ZA 8-21-2019  
Item # 5.a.  
Planning Department <planning@edcgov.us>  
(10 pages)

## Fwd: Variance: V18-0005/Chellappan & Notice of Public Hearing on August 21, 2019 (at 3:00PM)

## Response to V18-0005/Chellappan Variance

File Number: V18-0005/Chellappan Variance

**V18-0005 EXHIBIT J - DRIVEWAY LINE OF SIGHT ANALYSIS**

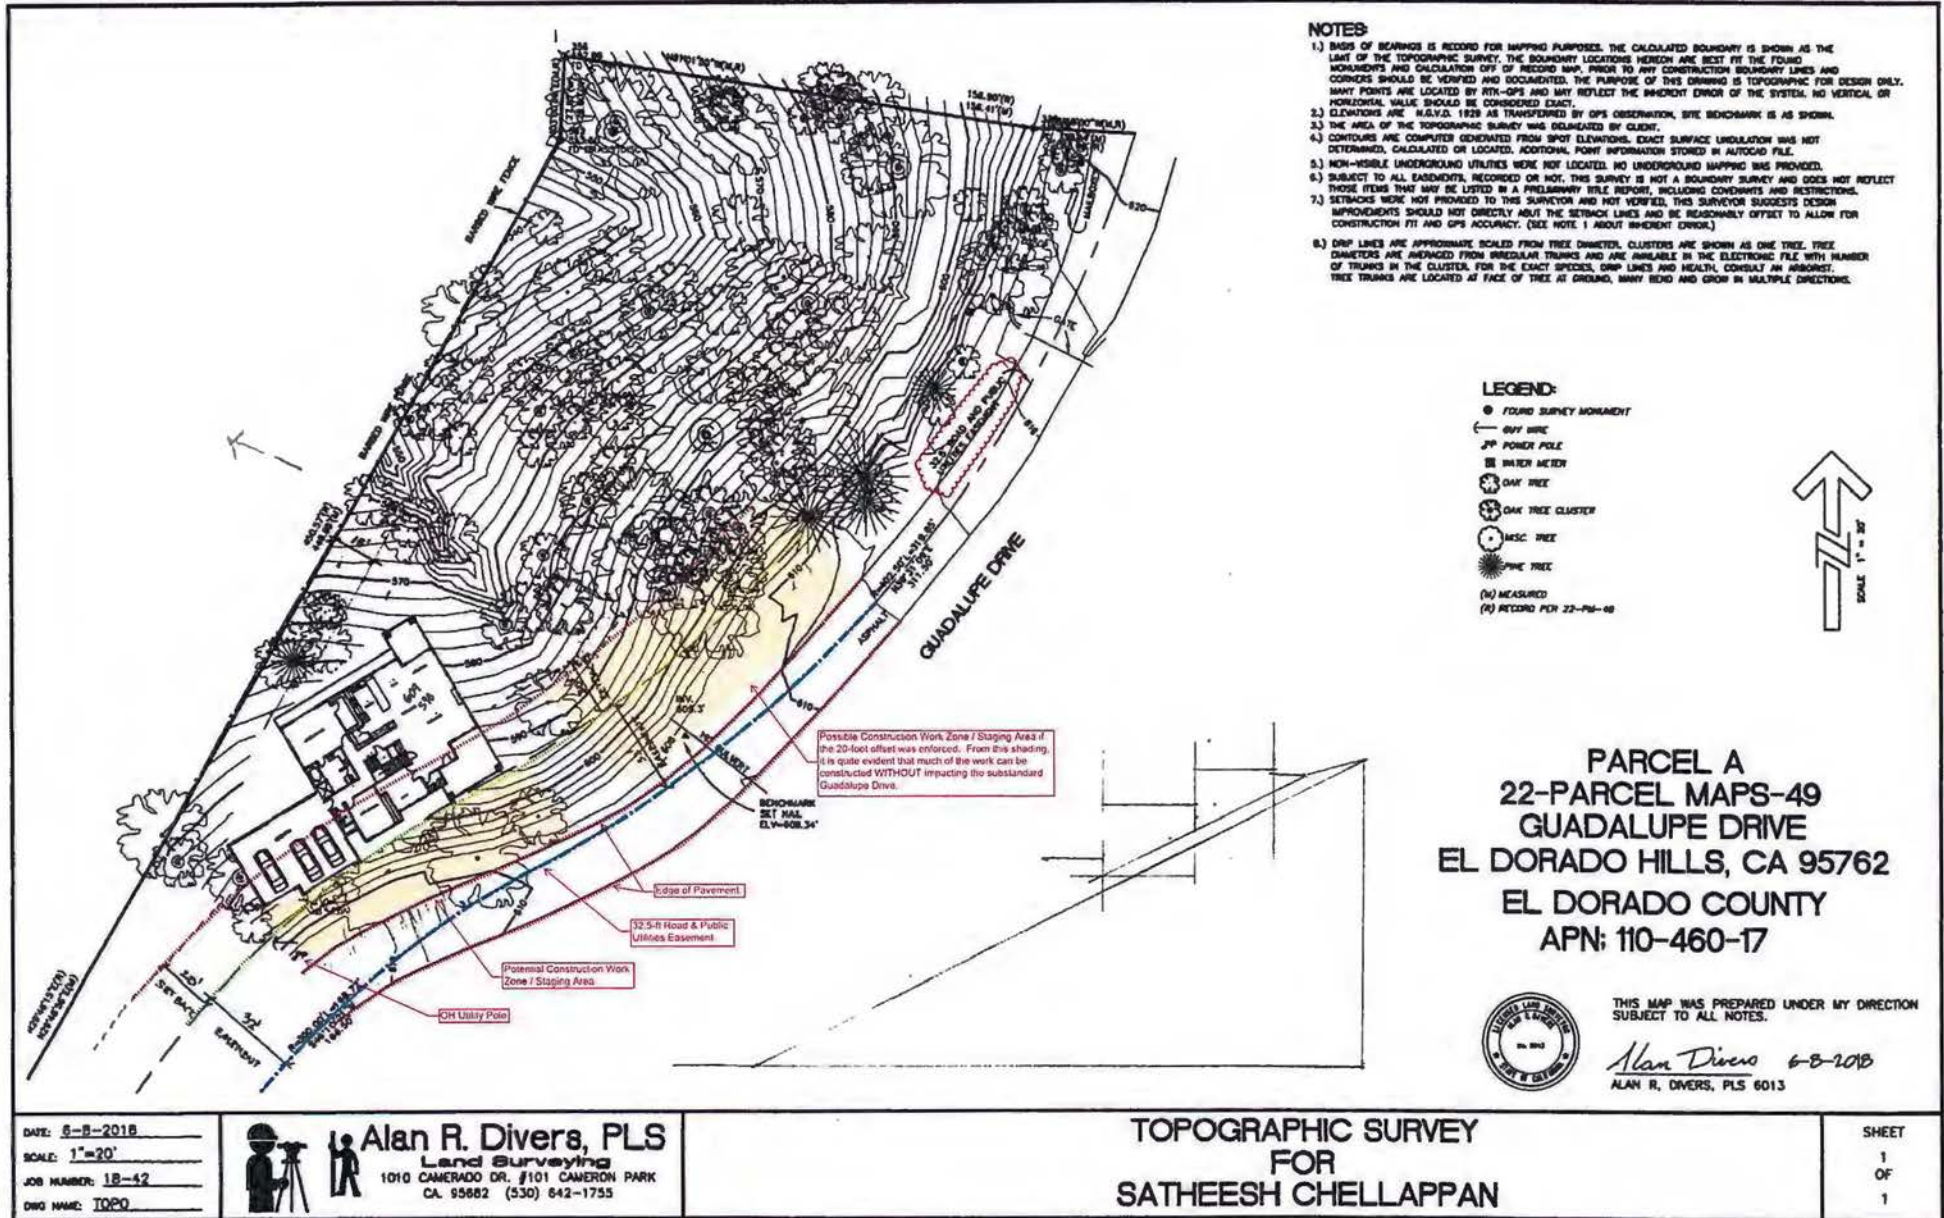
In Exhibit J, the analysis notes that the proposed driveway would have an adequate sight distance based on "DOT figure 201.2", and that the driveway would have "safe stopping sight distances of 100 feet for a left turn and 225 feet for a right turn". Again, this analysis does not appear to take into consideration the steepness of the proposed driveway, or if the vehicle were backing out of the driveway and onto Guadalupe Drive.
